Addendum Number: 01

Addendum Issue Date: December 1, 2023

Project Name: Marshall Public Library Renovation

Project Number: 0230585.00

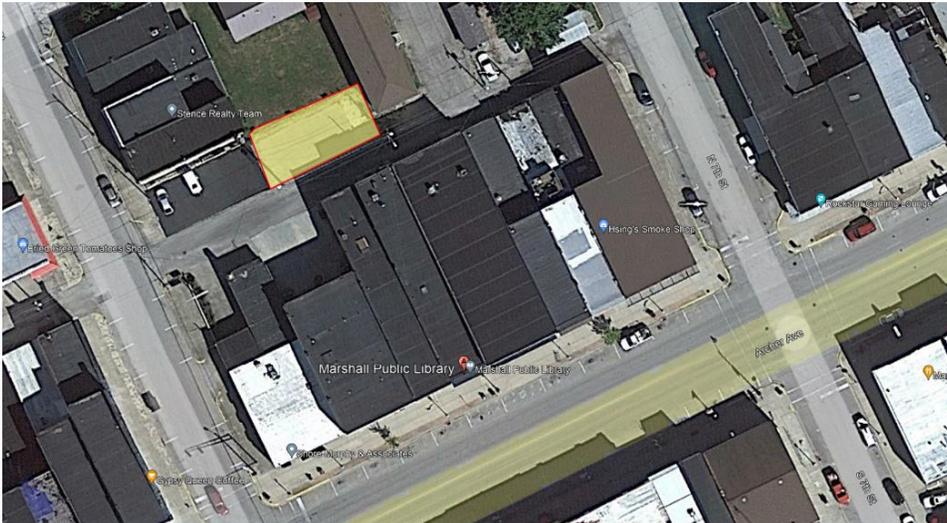
10. The contractor can place a dumpster in the lot directly across the alley on the north side of the building. Please refer to the image below for approximate location highlighted in yellow.

SHEET TITLE:
FIRST & SECOND FLOOR DEMOLITION PLAN

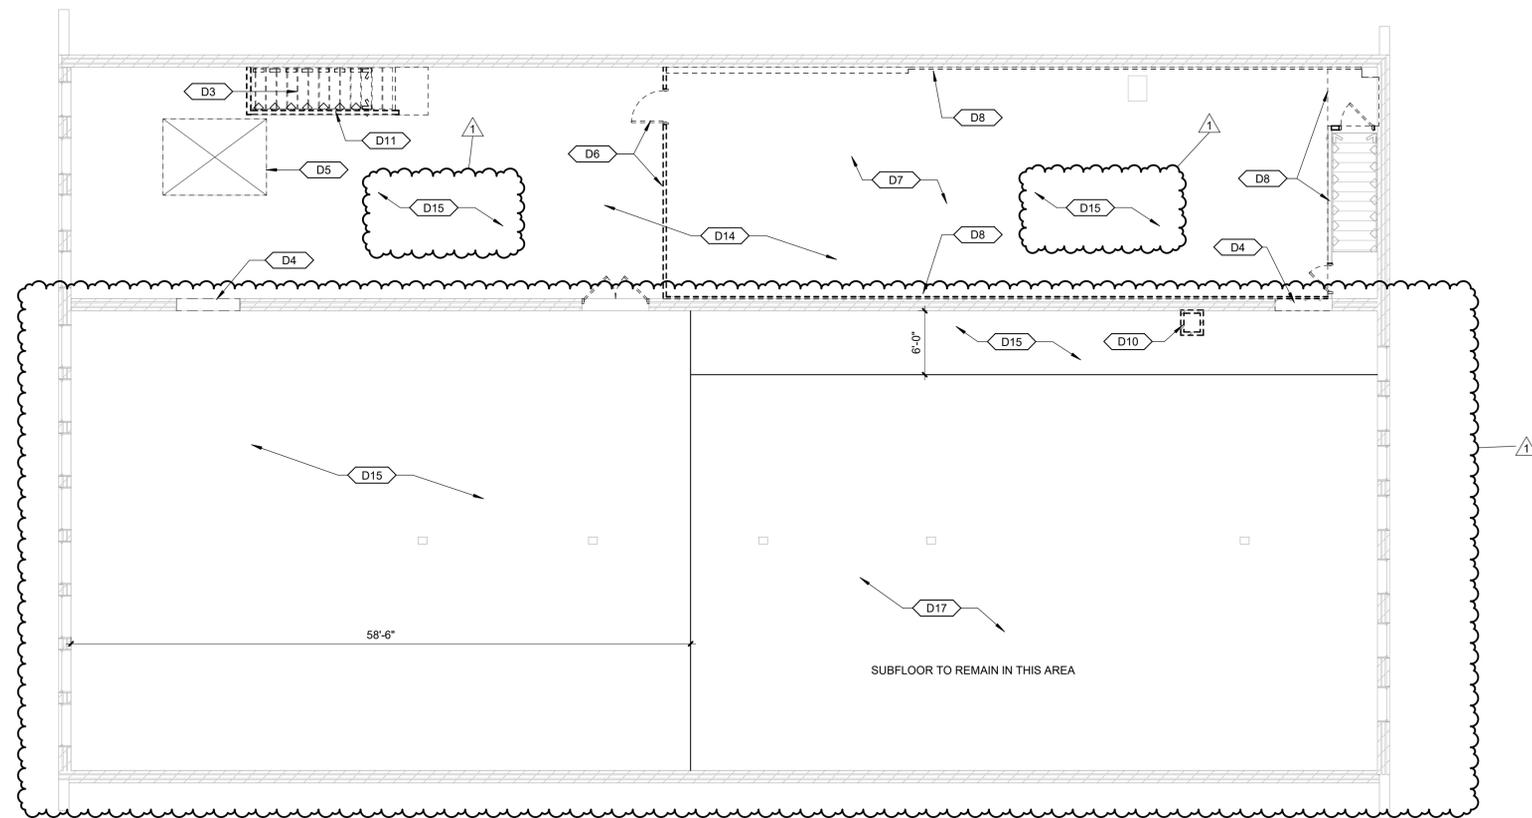
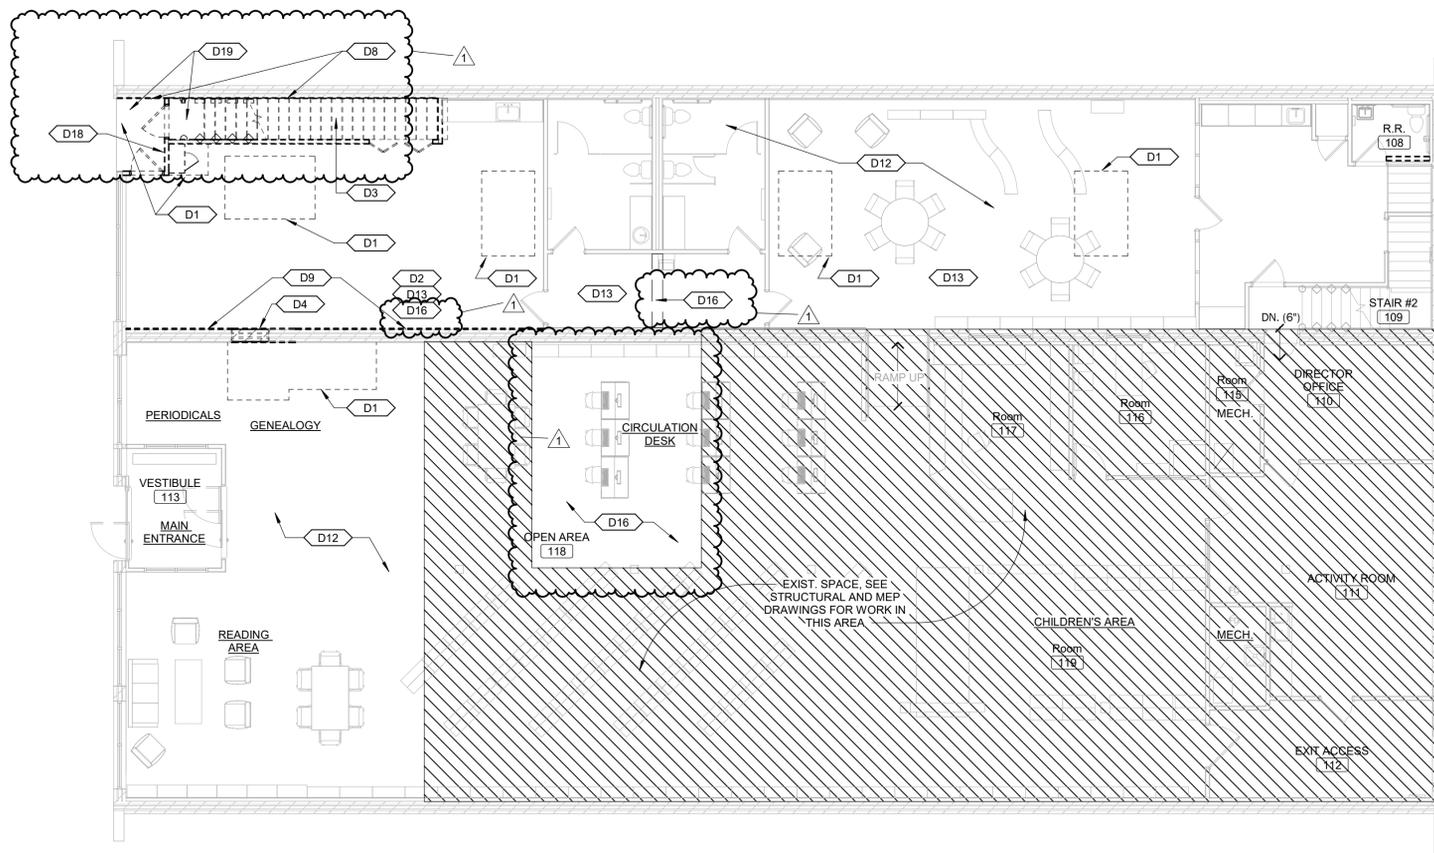
- a. The wood subfloor shall be removed on the west side throughout the entire space. The wood subfloor shall be removed on the east side where the new meeting room, future bathrooms, and future kitchen will be located.

- b. Keyed note 'D8' shall be modified to indicate that the existing wood paneling shall be removed to expose the existing brick substrate. The Contractor shall clean the masonry to provide a uniform appearance across the exposed brick area.

- c. Added keyed note 'D16'. The contractor shall salvage the existing decorative metal ceiling.
- d. Added keyed note 'D17'. On the east side of the building on the second floor, the contractor shall remove the batt insulation laid loosely over the existing subfloor.

- e. Added keyed note 'D18'. The existing plaque on the exterior of the building shall be removed, salvaged, and reinstalled at a location per Owner's direction.

- f. Added keyed note 'D19'. The existing ceiling and ceiling framing below second floor in stairwell and exterior alcove to be removed.

FIRST & SECOND FLOOR PLAN

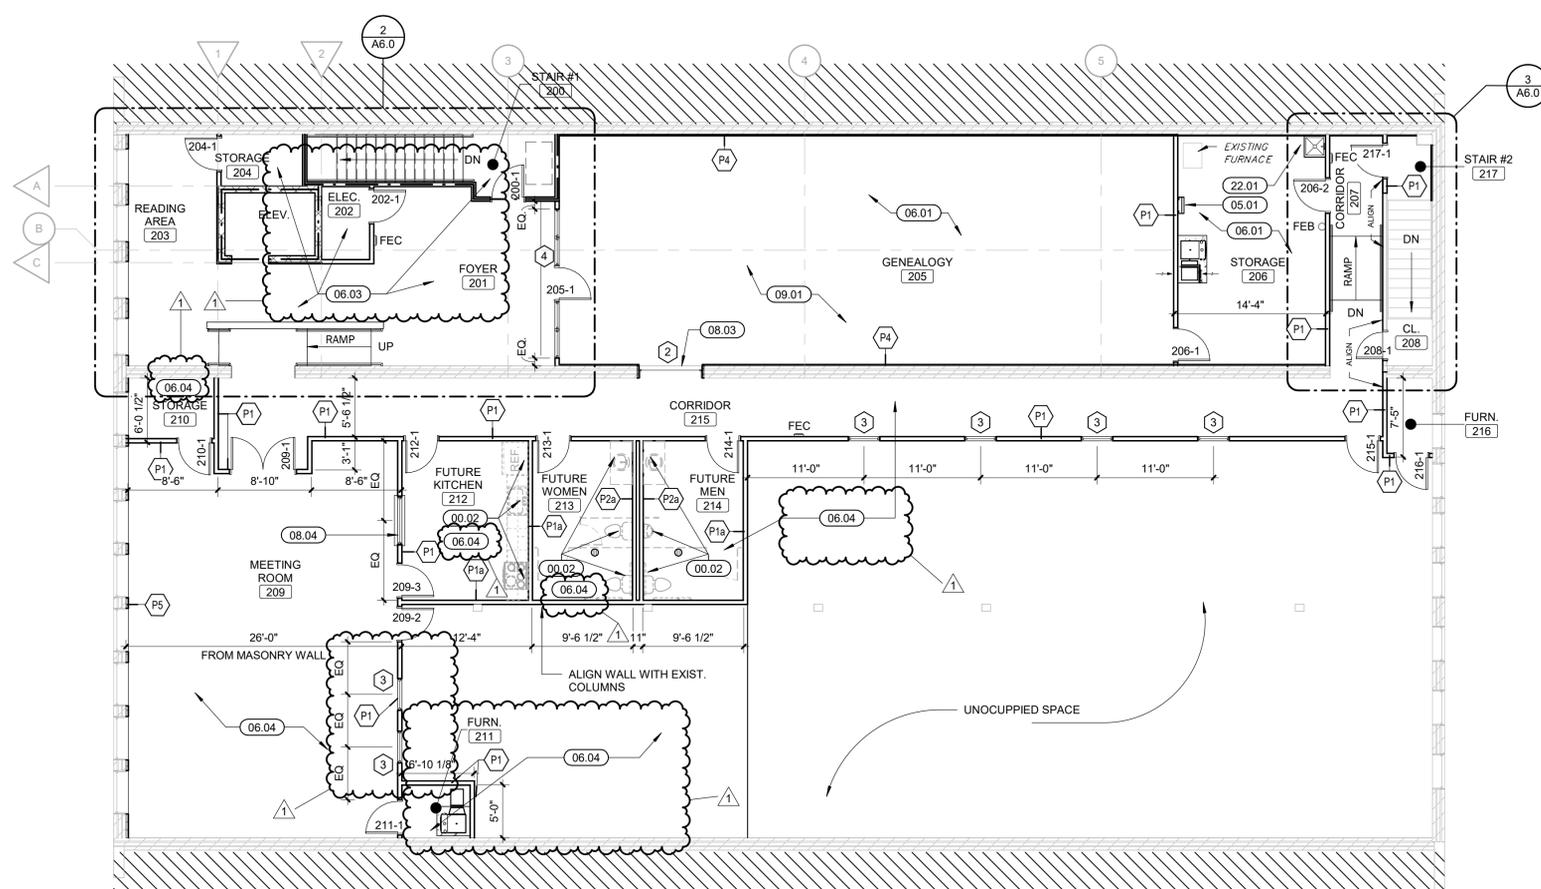
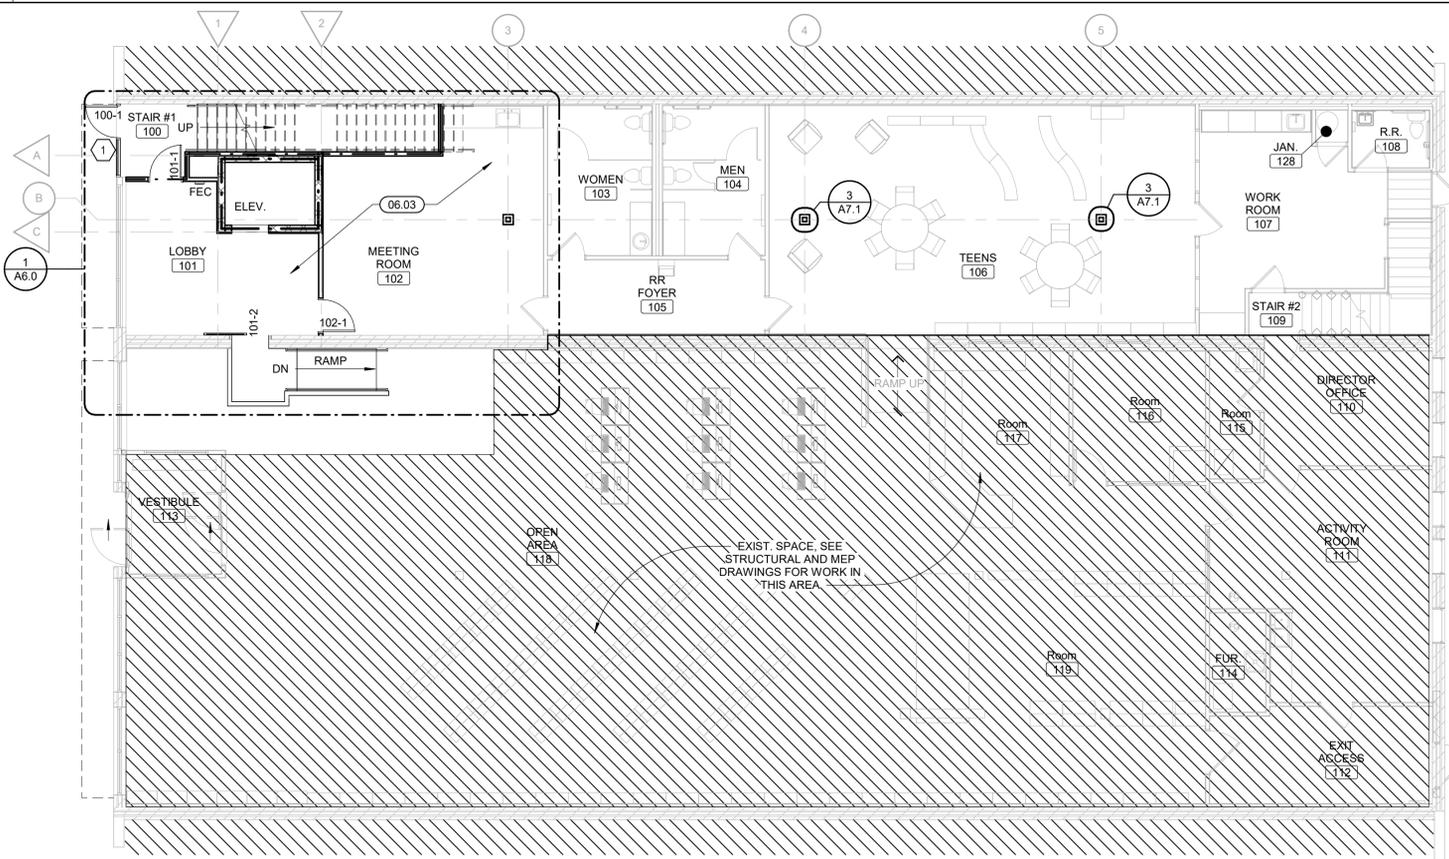
- a. Keyed note '05.01' shall be modified to remove the roof hatch by others. The roof hatch shall be furnished and installed by the contractor.
- b. Keyed notes '06.01' and '06.03' shall be modified to clarify that the new plywood subfloor shall be installed over the wood joists.
- c. At locations with new wood subfloor, loose fill batt insulation shall be added between the joists. Soundproofing underlayment shall be added to the top of the new wood subfloor.

- d. Additional keyed notes '06.03' and '06.04' have been added to clarify locations of the proposed new subfloor.
 - e. Window type '3' shall be added in the north partition of Meeting Room 209.

VERTICAL CIRCULATION

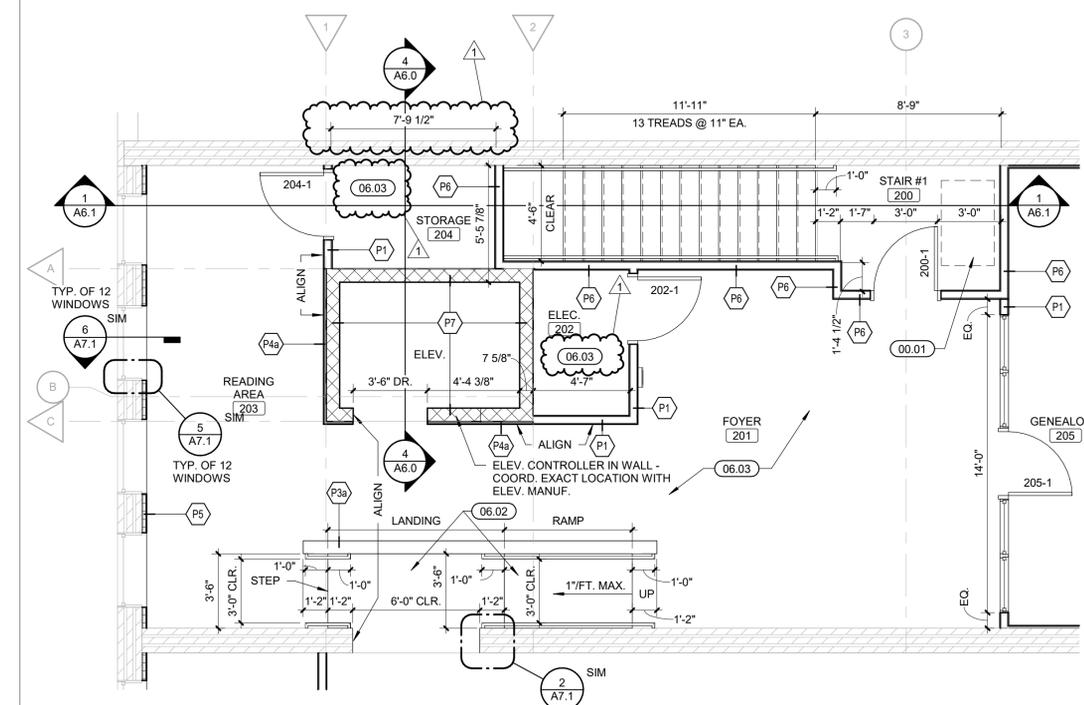
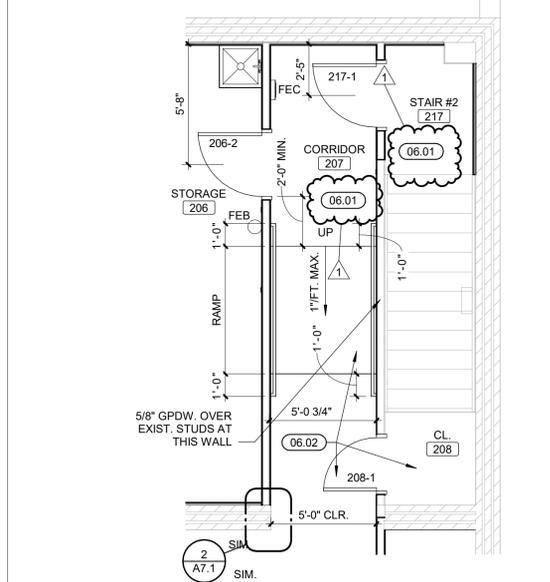
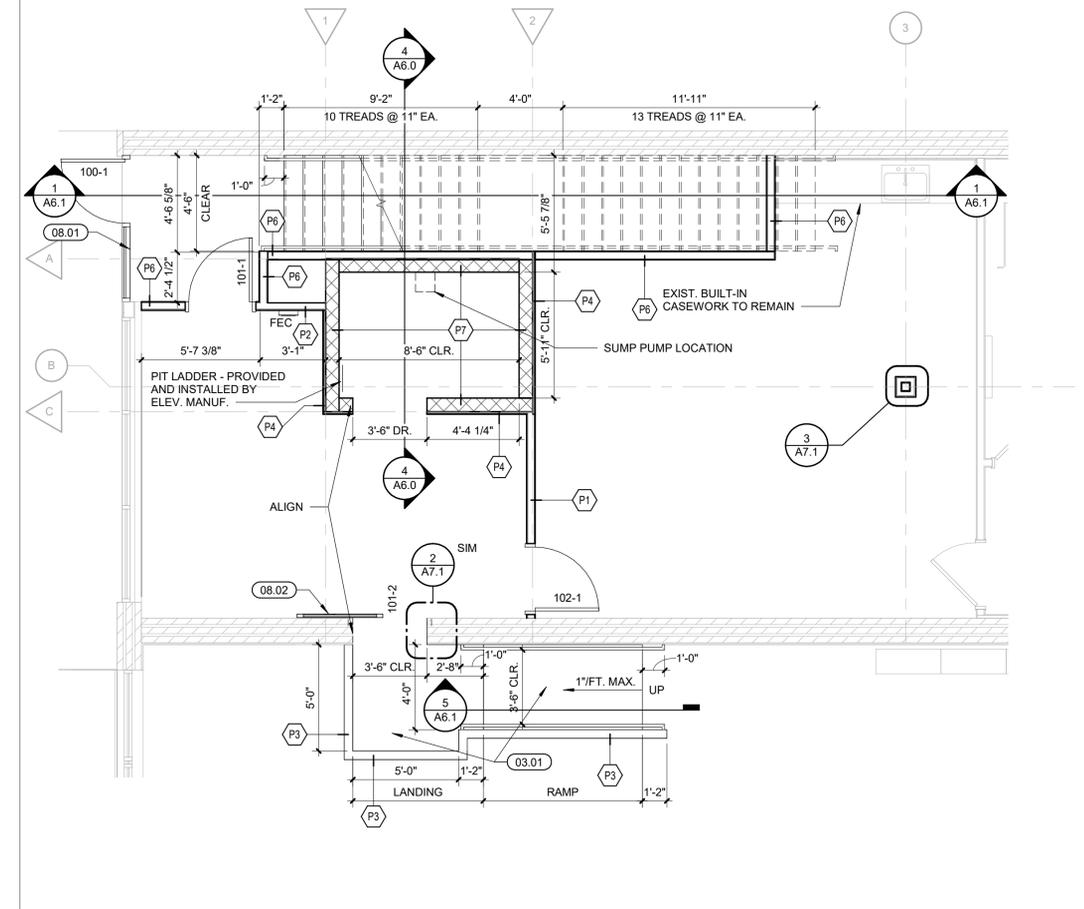
4. A6.0 – Vertical Circulation
 - a. The clearance from the second floor to the bottom of the hoist beam shall be 12'-8".
 - b. Additional keyed notes '06.01', '06.03', and '06.04' have been added to the enlarged second floor plan details to clarify locations of the proposed new subfloor.

- e. Additional dimensions have been added to the enlarged plans.
 5. A6.1 – Vertical Circulation
 - a. Detail 5 shall be revised to be a wood ramp.
 - b. The furring of the existing south wall in the new stair shall extend down the entire wall.

4 ELEVATOR SHAFT SECTION
Scale: 1/2" = 1'-0"

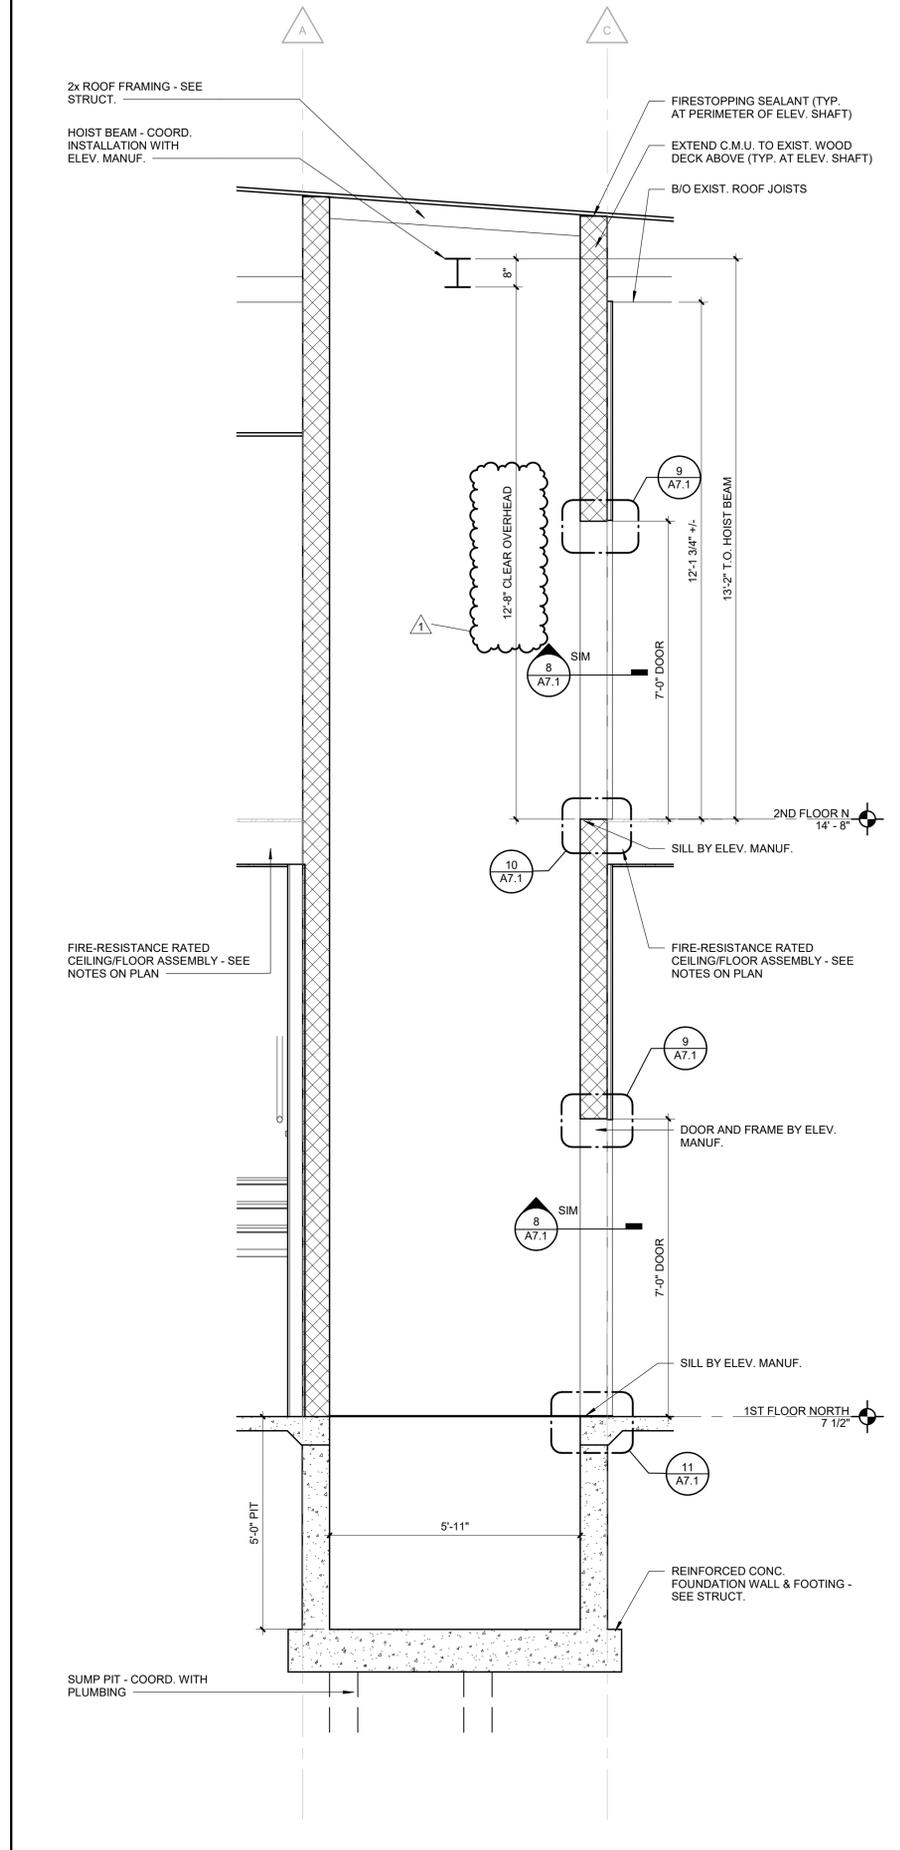
- c. Detail tags for the elevator threshold, jamb, and head conditions have been added to Enlarged Shaft Section 4/A6.0.
 - d. The hoist beam shall be 12'-8" clear overhead in lieu of 12'-6".

7 BEAM ENCLOSURE DETAIL
Scale: 1 1/2" = 1'-0"

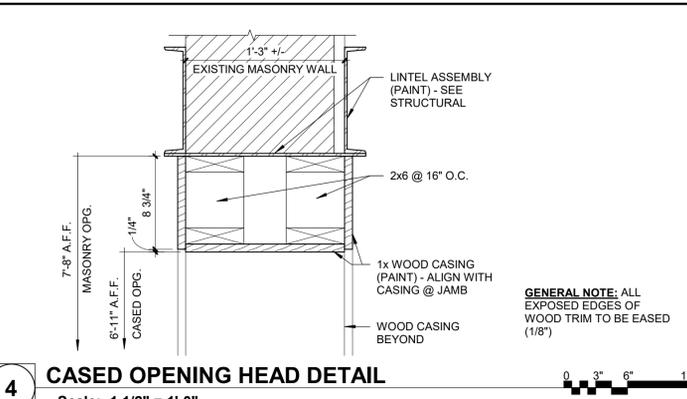
- c. Detail 7 – Trim notes have been added to the column for beam enclosure at 'SIM' condition.
 - d. Detail 8, 9, 10, and 11 for the elevator threshold, jamb, and head conditions have been added.

3 ENLARGED COLUMN PLAN
Scale: 1 1/2" = 1'-0"

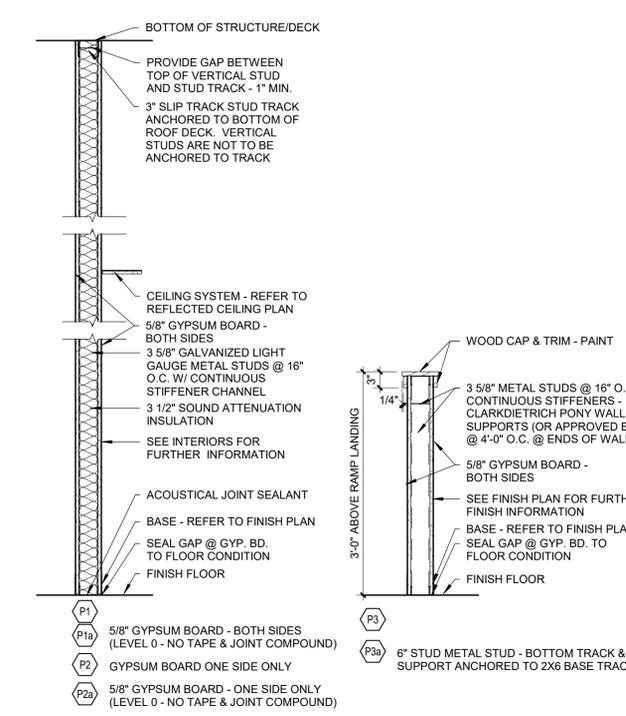
- b. Detail 3 – In lieu of 2 ½" metal studs, 2x wood framing to fur out steel column shall be used. Trim notes for the top and bottom of the column have also been added.

8 STOREFRONT - HEAD DETAIL
 Scale: 1 1/2" = 1'-0"

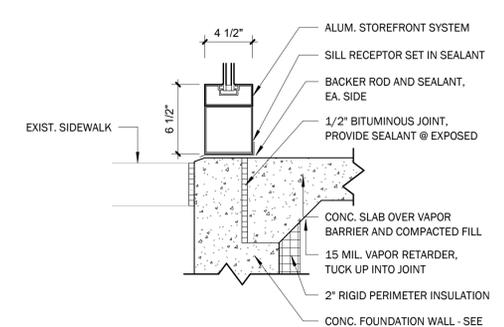
- c. Detail 8 – Rigid insulation has been added to the detail above the aluminum storefront.
 8. A9.1 – First & Second Floor Reflected Ceiling Plans
 - a. Modified keyed note '09.02'. The proposed soffit in Open Area 118 to conceal the plumbing piping shall be constructed utilizing 2x wood construction.

14 JAMB DTL. @ BORROWED LITE WINDOW
 Scale: 1 1/2" = 1'-0"

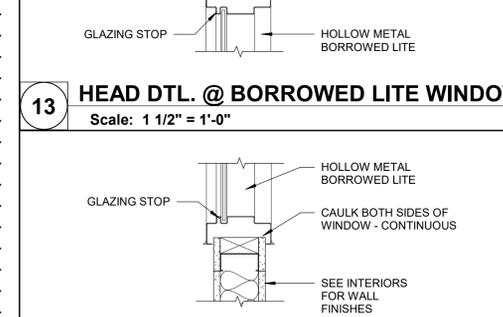
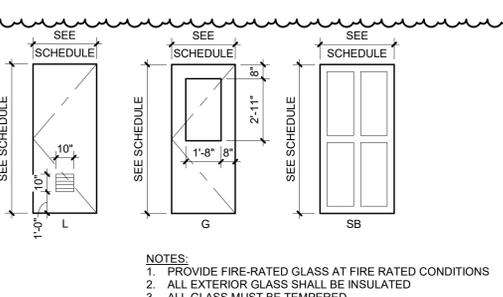
7. A7.2 – Door Schedule, Elevations, & Details
 - a. Detail 12, 13, and 14 have been added to the sheet indicating hollow metal borrowed lite details.
 - b. The bottom rail for the aluminum threshold indicated on details 6 and 7 shall be 10".
